Subject: Final Rule, Response to Petitions for Reconsideration, Technical Amendment, Docket No. 2008-0111, Anthropomorphic Test Devices; ES-2re Side Impact Crash Test Dummy 50th Percentile Adult Male.

First Technology Safety Systems (FTSS) has reviewed the February, 2008, ES-2re dummy drawing package (identified in the above mentioned technical amendment) and we have identified a number of drawing errors and a number of drawing issues. We seek to petition NHTSA to correct these drawings to ensure that the ES-2re dummy continues to meet the same dimensional and performance requirements established for the dummy when the dummy was proposed for inclusion into 49 CFR Part 572 Subpart U. FTSS makes the following comments and recommendations with respect to the drawing package. A marked up drawing for each of these recommended changes are attached to the end of this letter.

NATIONAL HIGHWAY TRAFFIC SAFETY ADMINISTRATION	
ILIAC WING ASSEMBLY, LEFT	
SIZE A1	SHEET 1 OF 1
DRAWING NUMBER 175-6010	REV. B

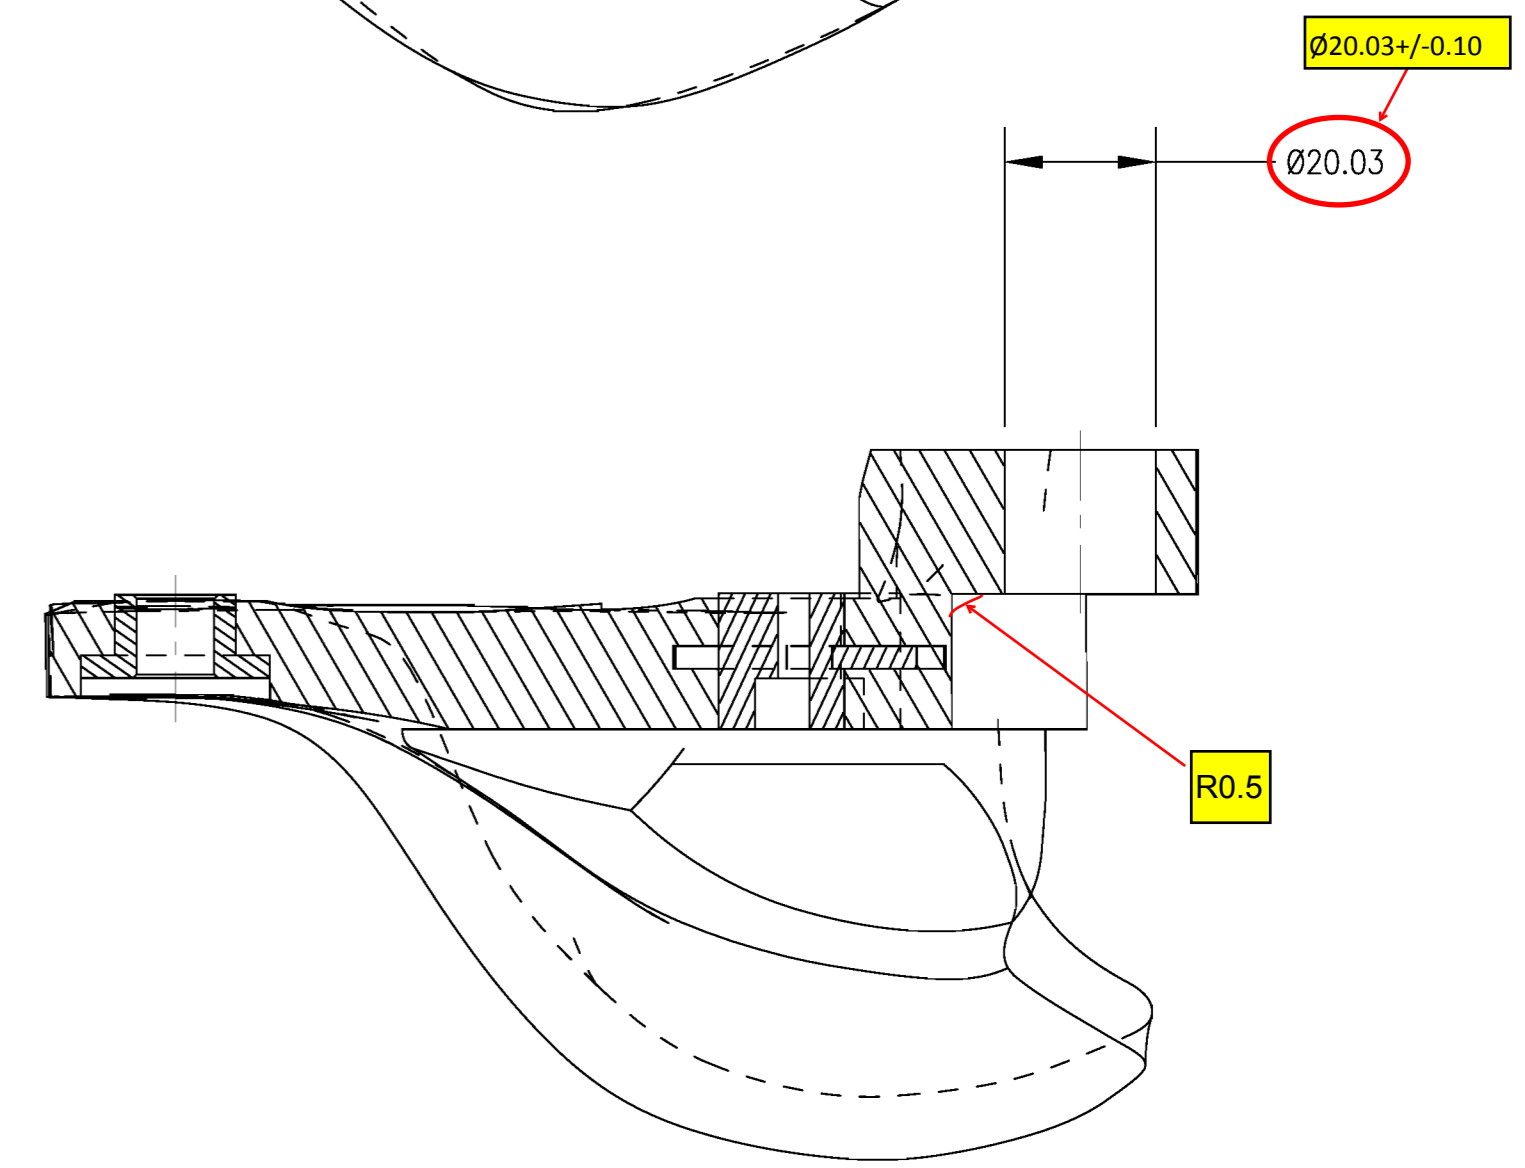
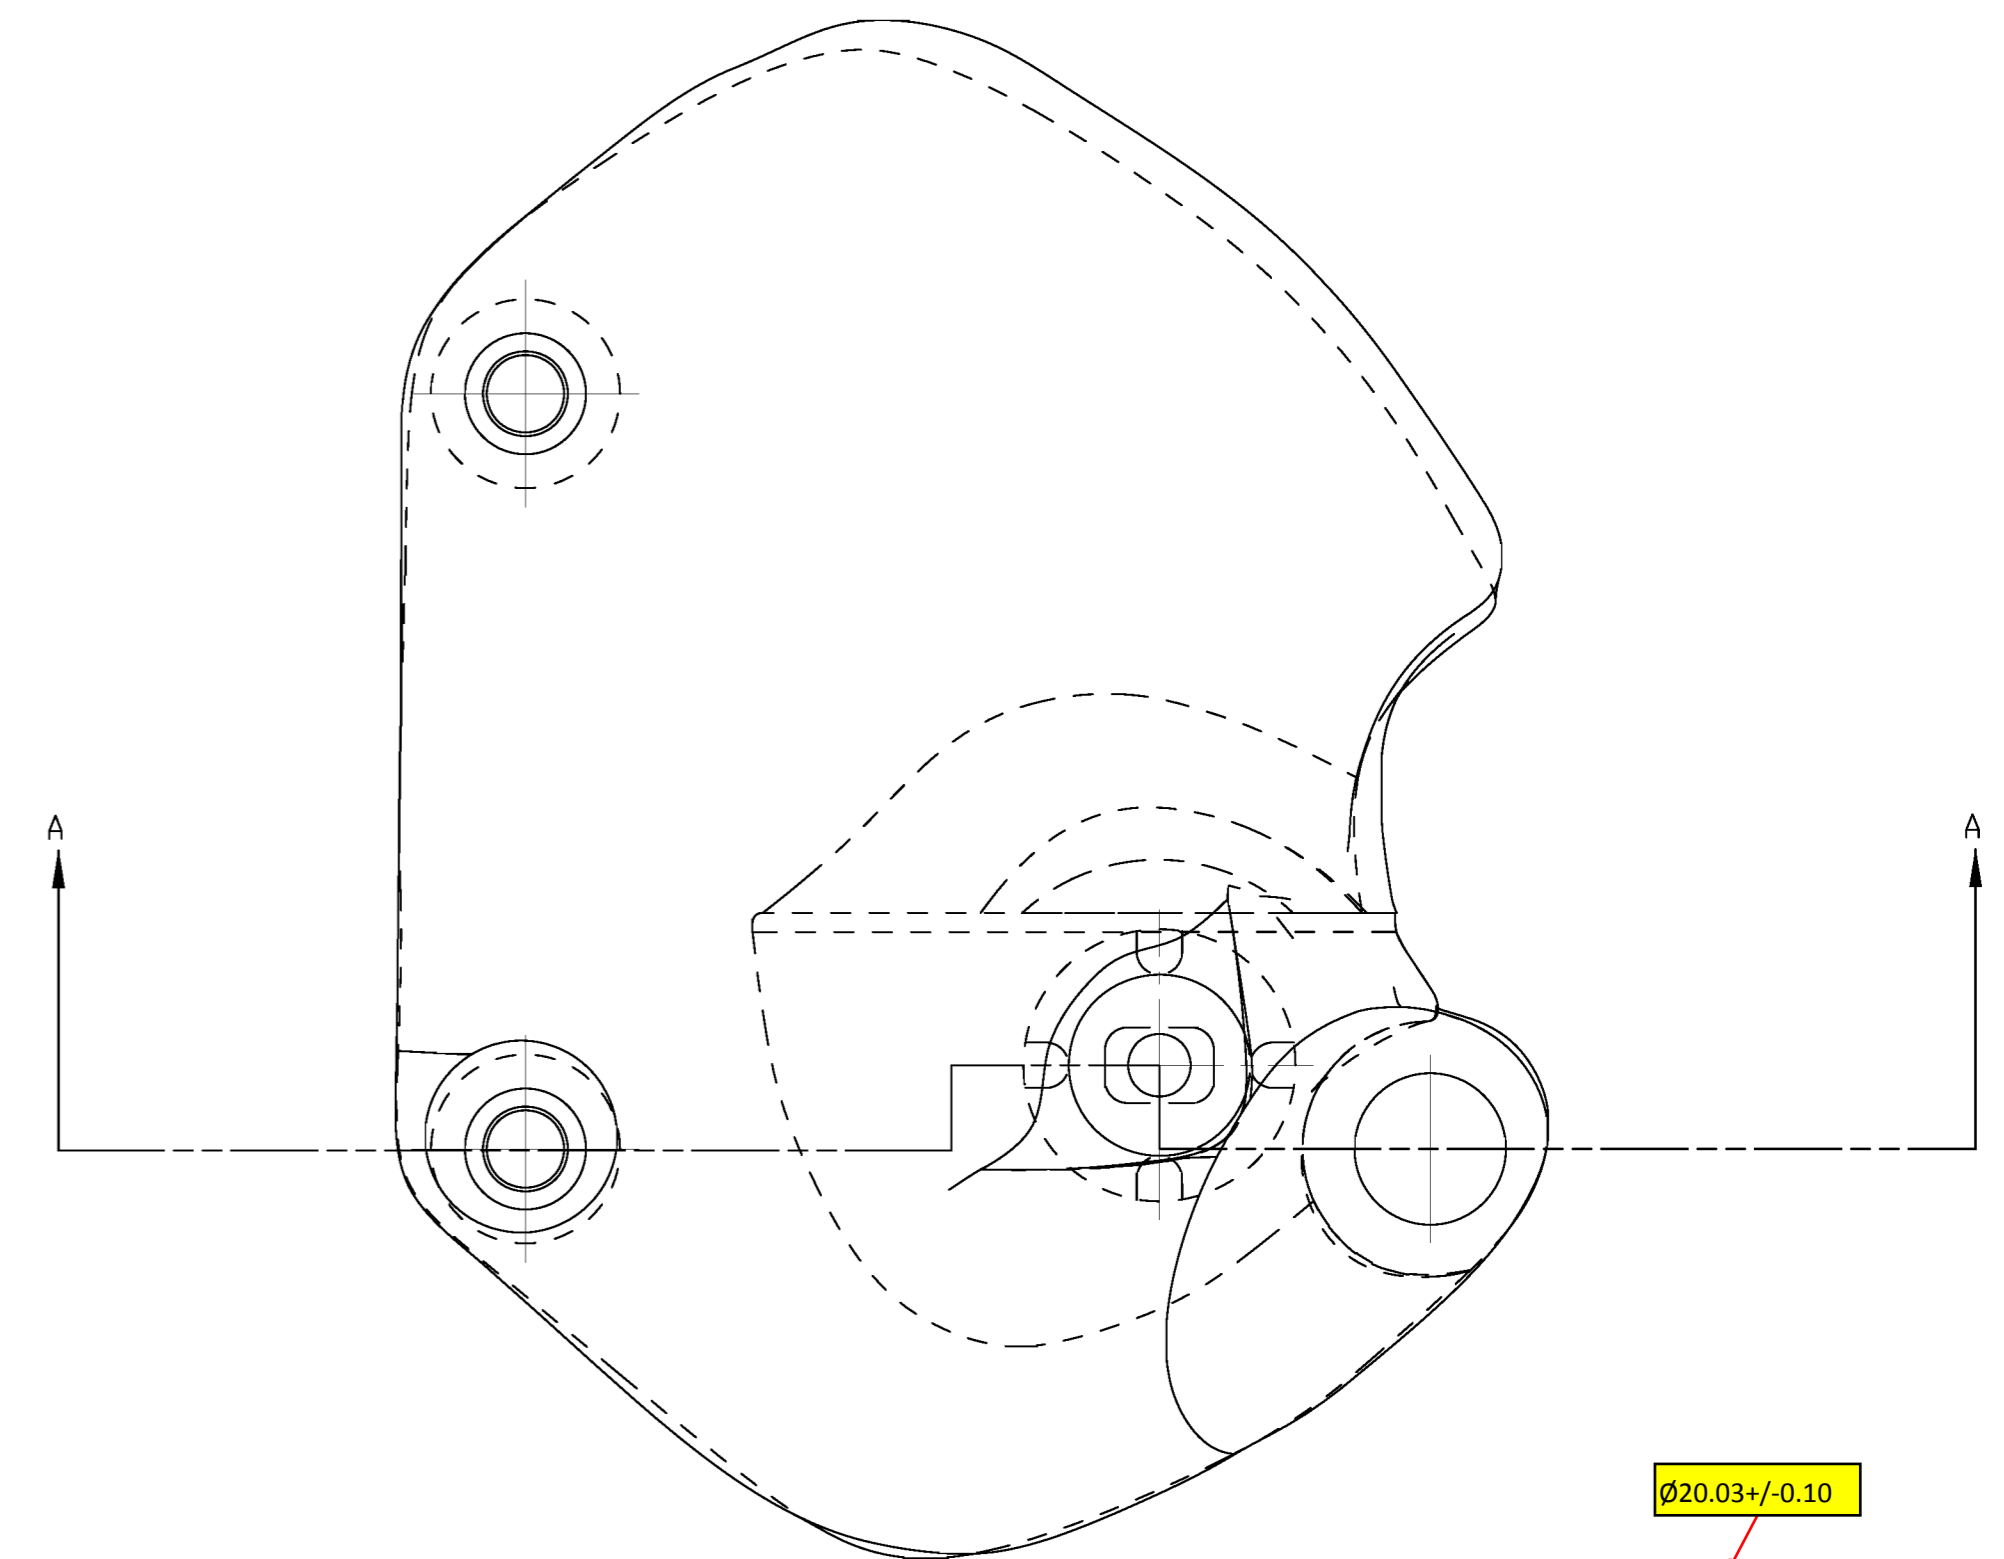
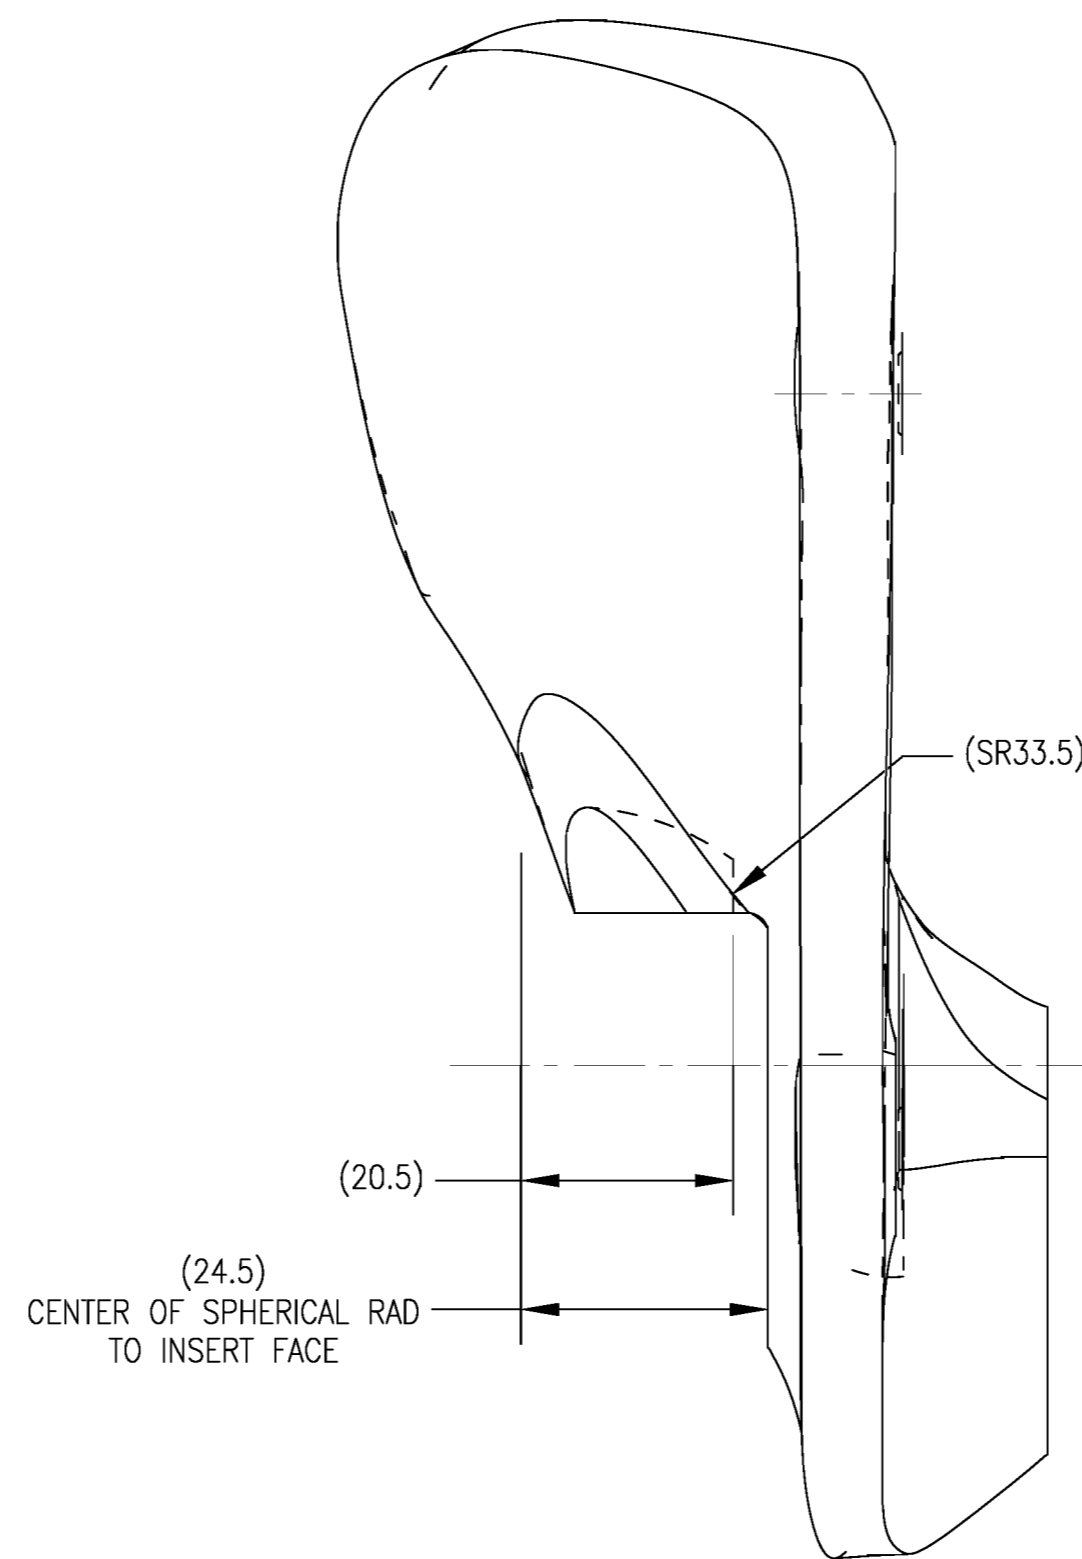
- 5) Drawing 175-6010, Iliac Wing Assembly, Left. Fix typographical error for drawing dimension "17.0556". This dimension should be "17" since it is not reasonable to control and measure this molded part to four decimal places and "17" also matches the same dimension as the Iliac Wing Assembly, Right (NHTSA Drawing 175-6002). FTSS also recommends that the drawing dimension "Ø20.03" be replaced with "Ø20.03 ± 0.10" since this dimension cannot be controlled to a tolerance of ± 0.05. We also recommend the addition of dimension "R0.5" to better define this location for easier machining of this particular section of the part and to prevent breakage due to concentrated stresses.
